Re: **129 W. Genesee Street Splash Car Wash – Site Plan Review**

The following letter has been written in response to the review comments from Napierala Consulting dated August 18, 2022, received from the Village of Fayetteville on August 24, 2022. The following comments have been addressed below.

DRAWING TITLE: **UTILITY PLAN**

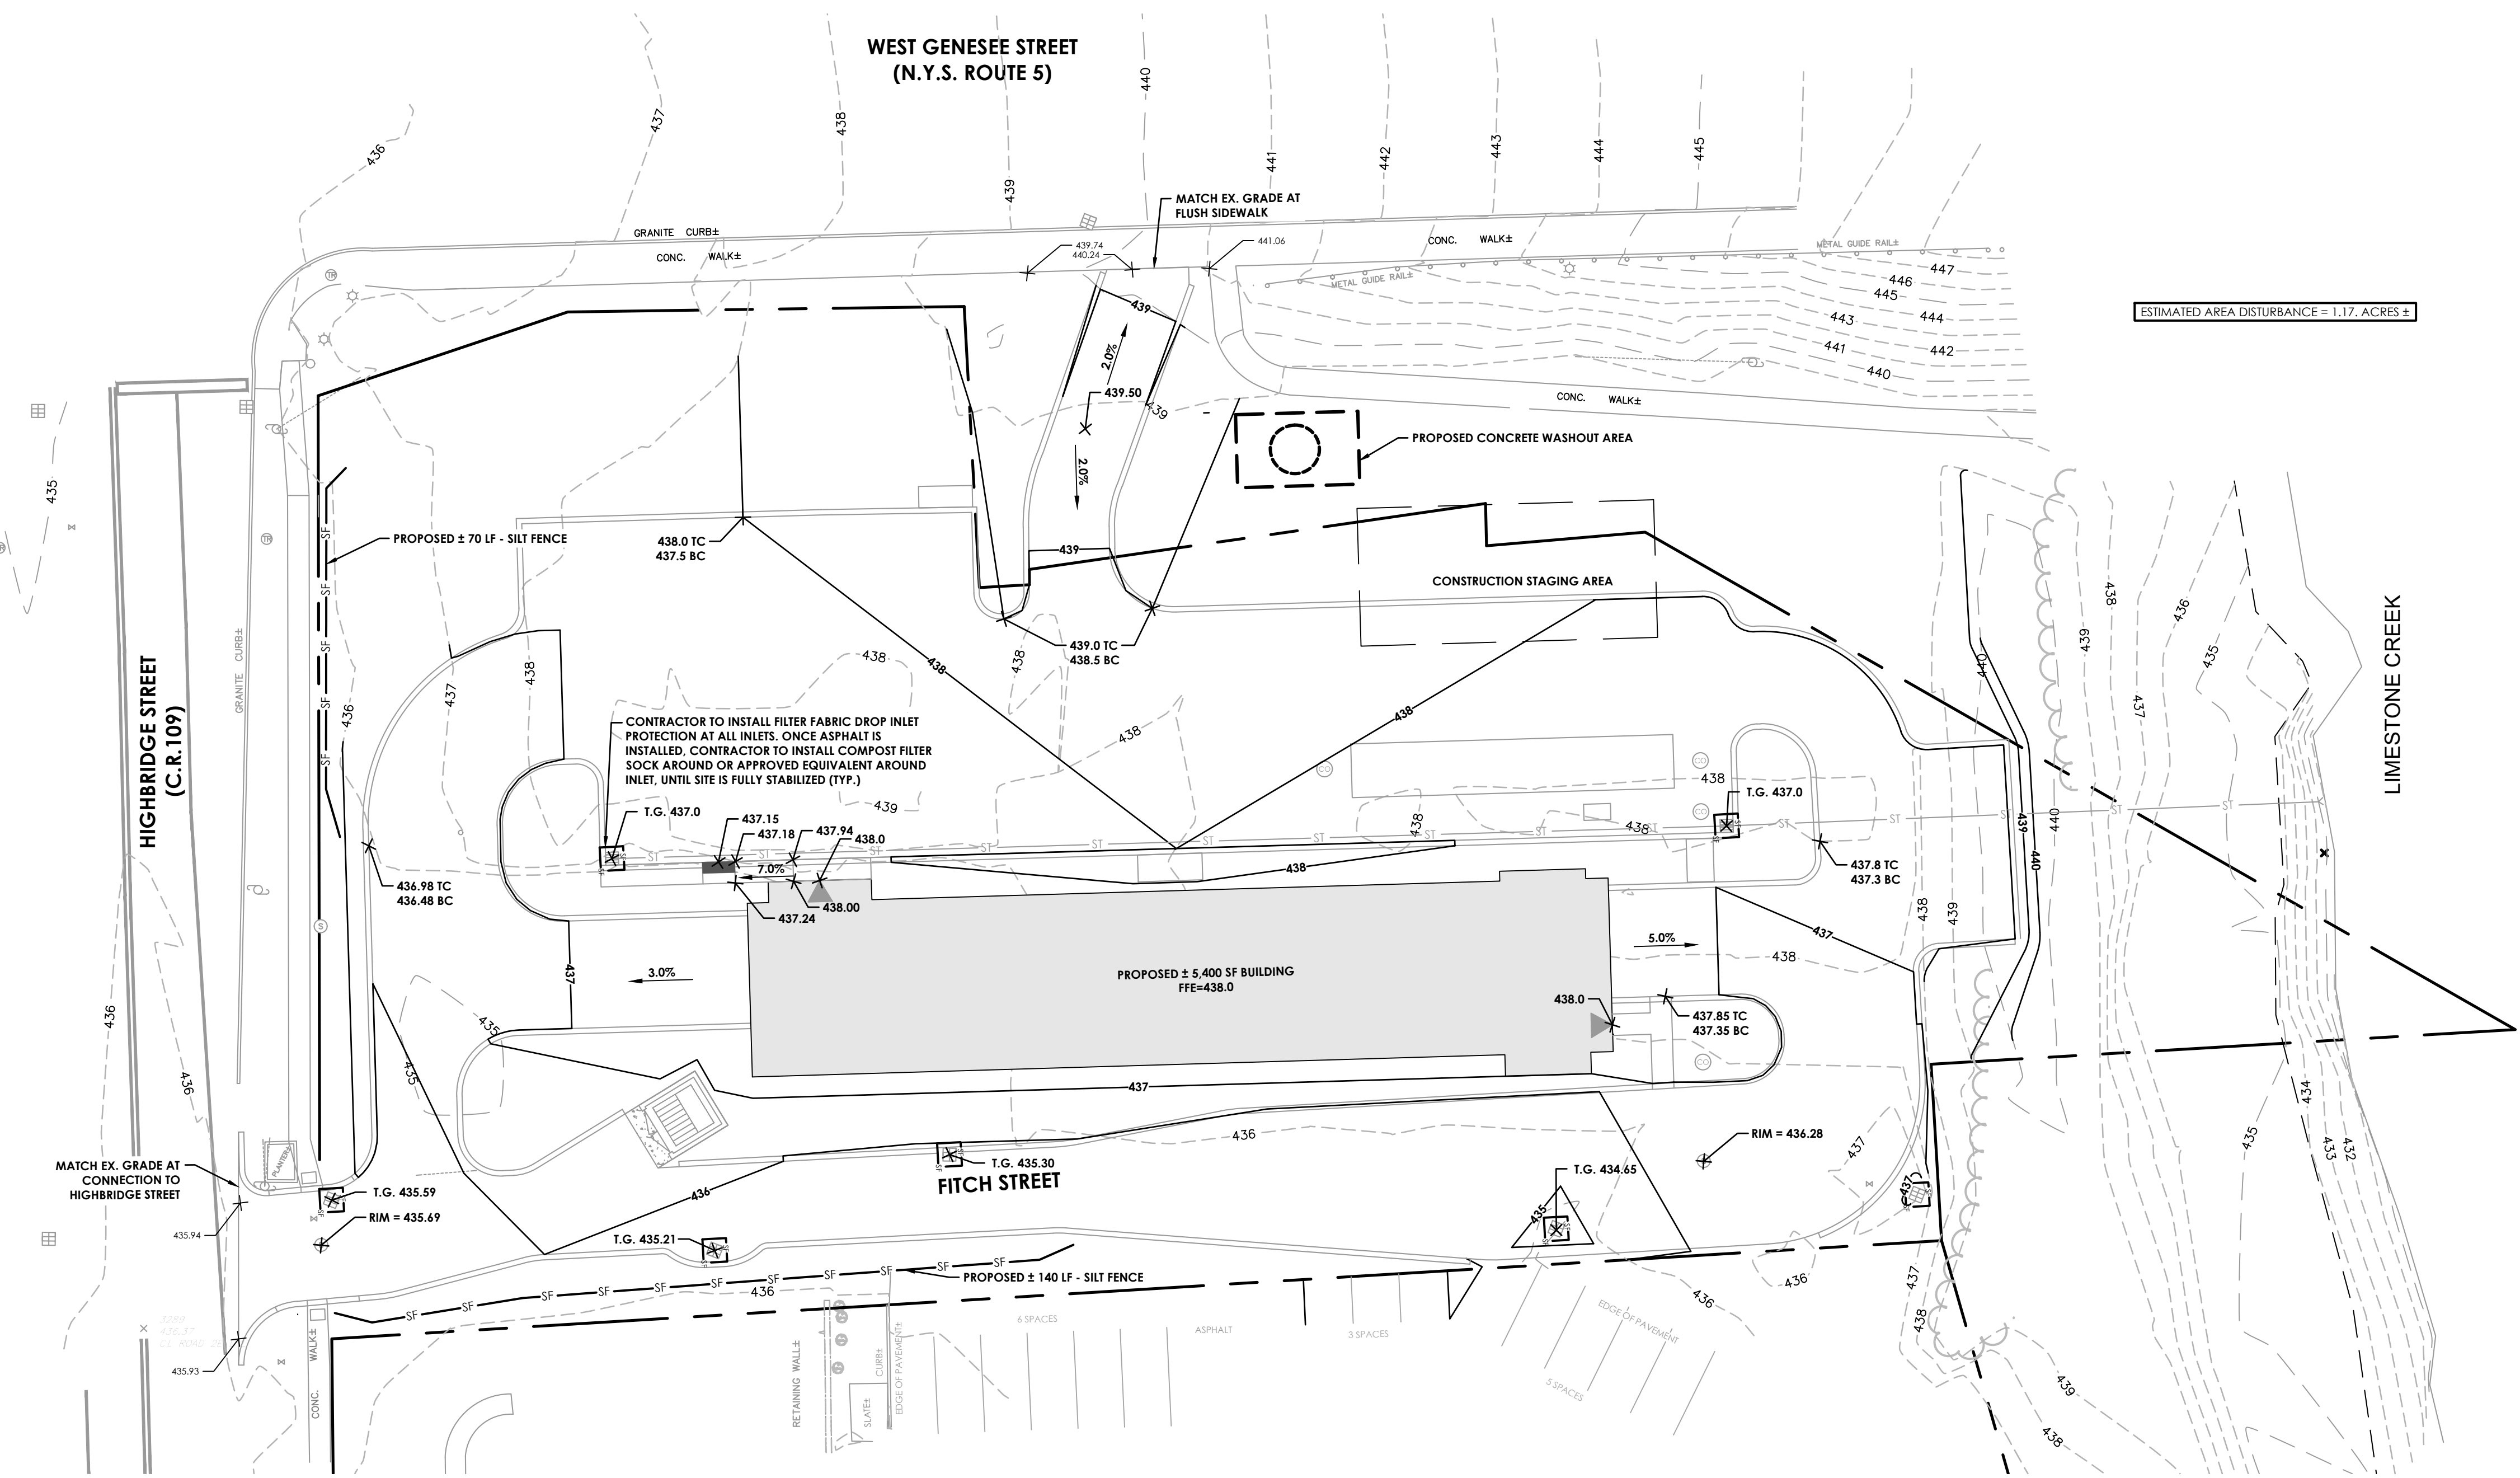
3) Utility Plan, C4

- e. Provide details for water recycling system and oil water separator.

- g. Show existing overhead electric on the plan, possible interference with the dumpster/trash removal process.

Notes have been added to the plan for the contractor to access/assess the condition of the existing storm sewer and replaced if the Village inspector deems it necessary.

Please see Utility Plan. There is no expected conflict with existing overhead electric and the dumpster/trash removal process.

REV:	DRAWING NO:
01	C5

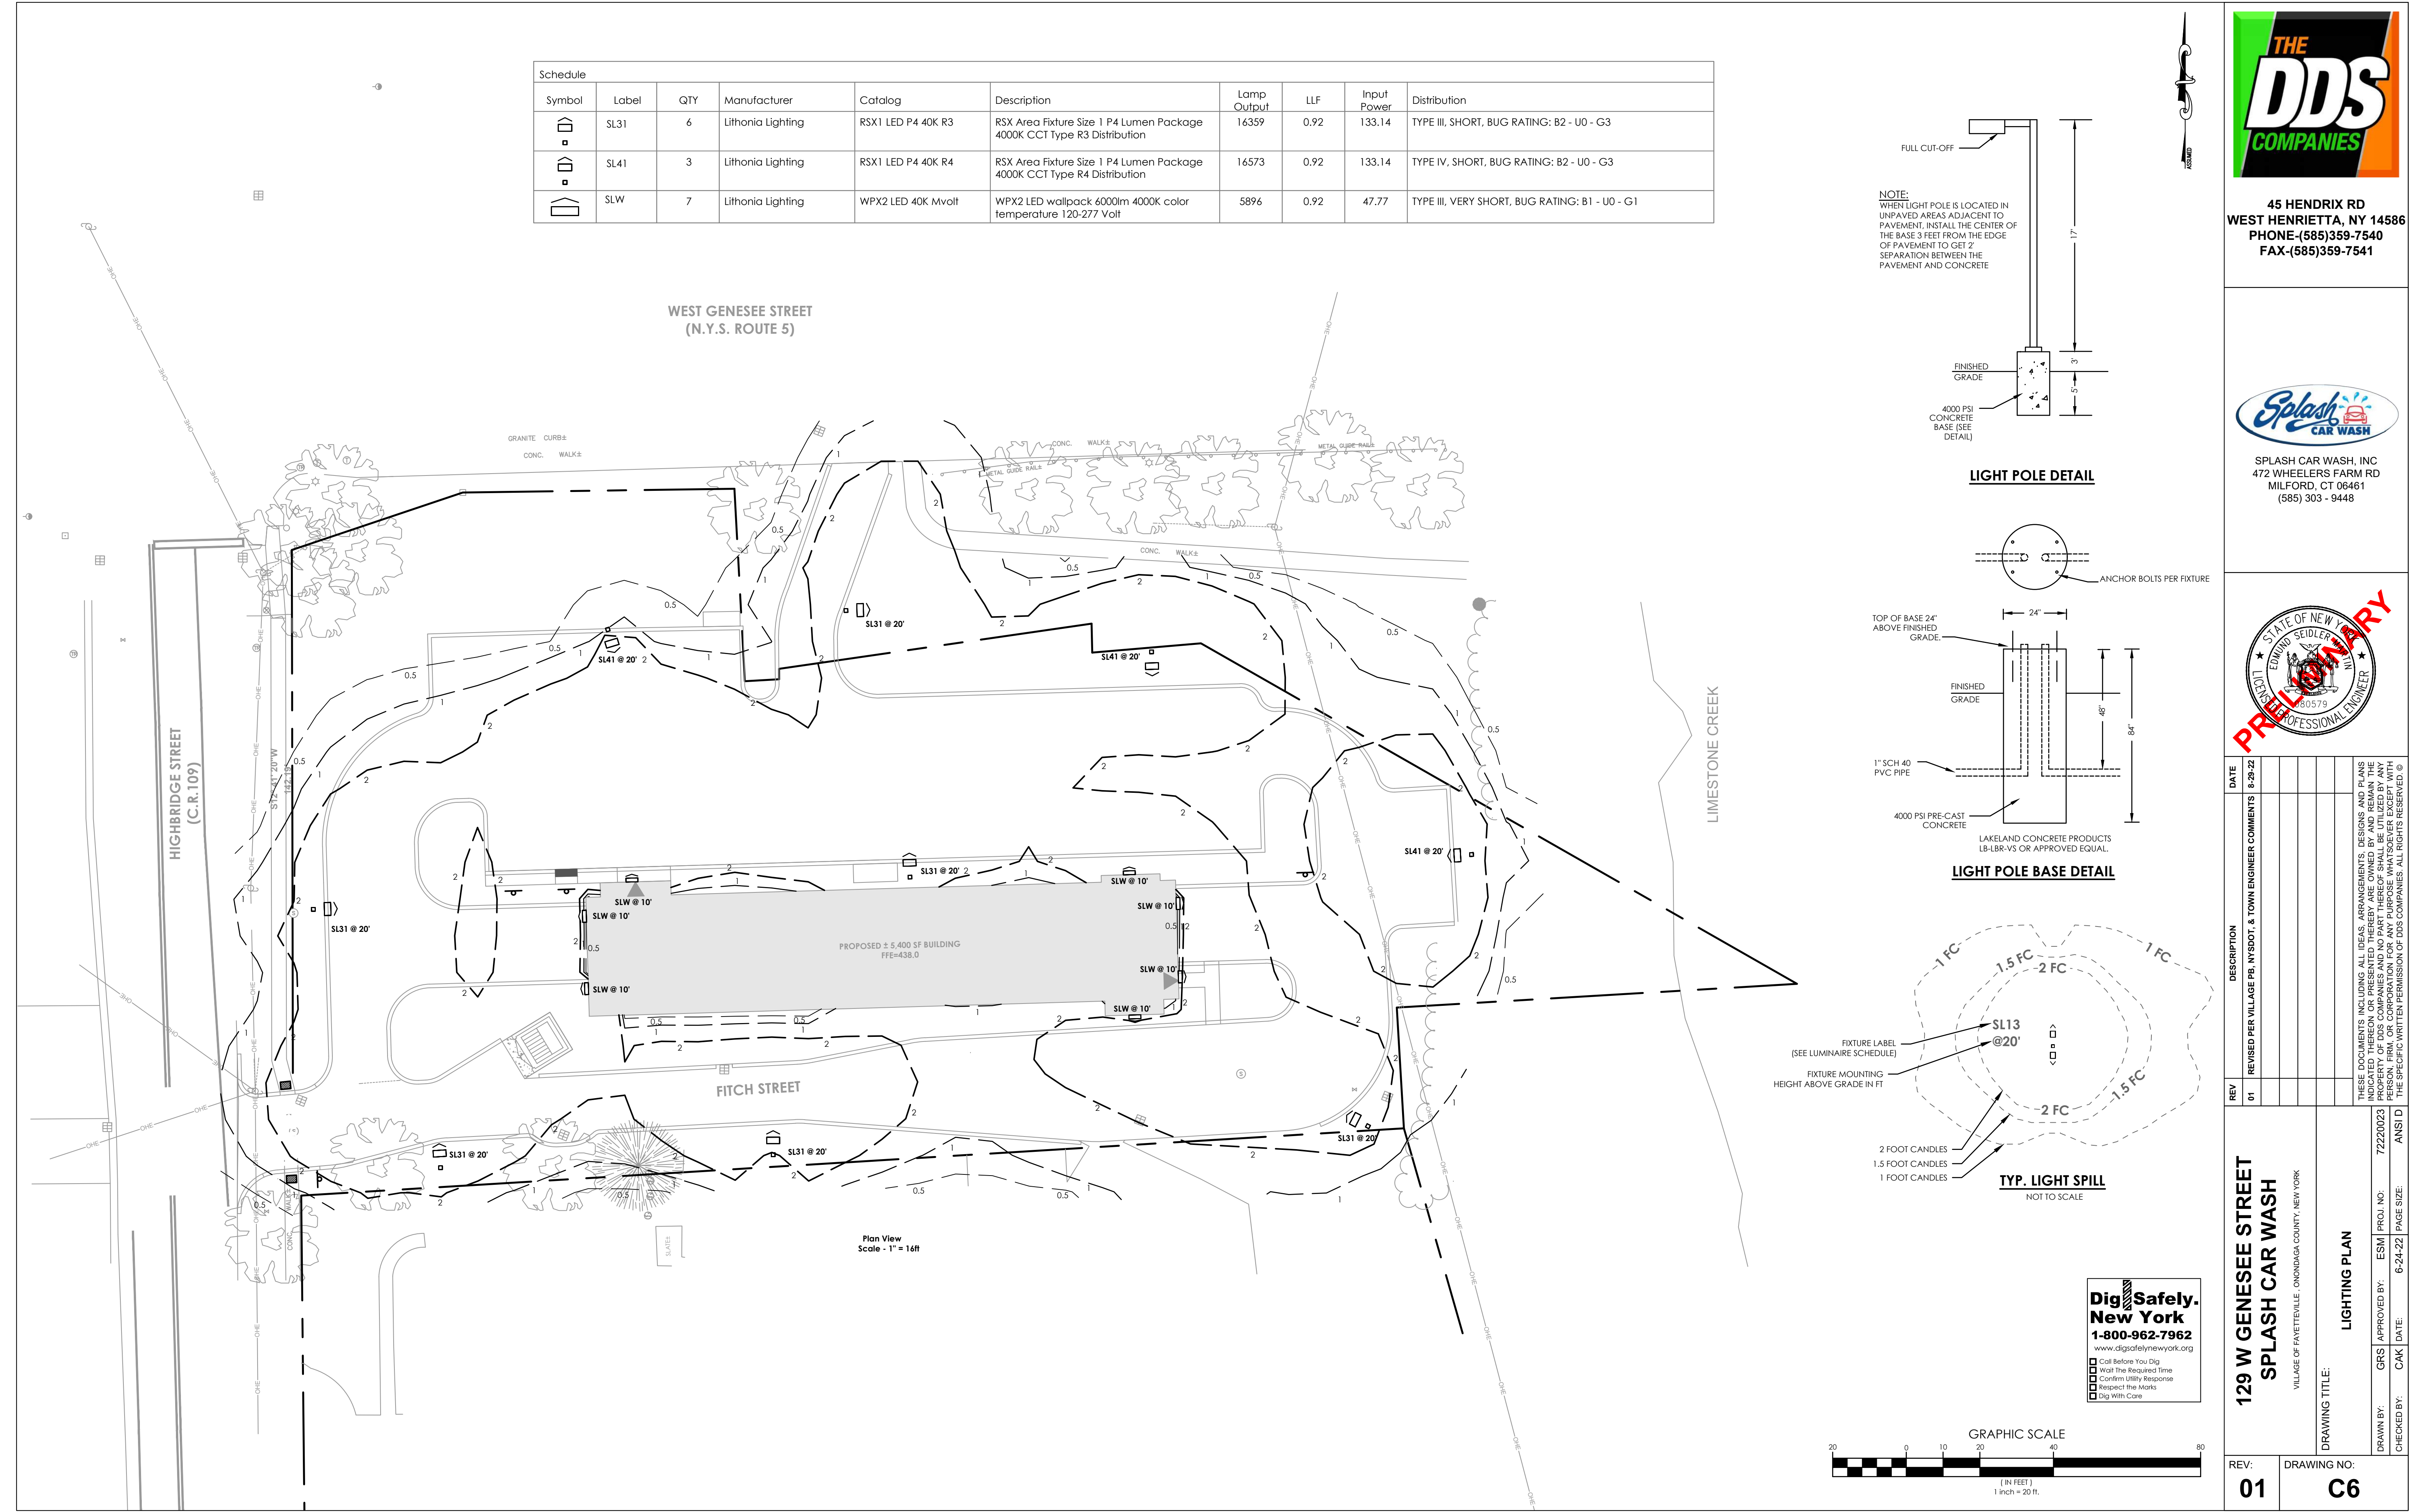
4) Grading Plan, C5

- a. The site is within the floodway as noted in the applicant's engineers report. The applicant needs to provide a flood study with earthwork calculations for review of impact and evaluation of "net decrease in fill" statement.

Please see revised Grading Plan.
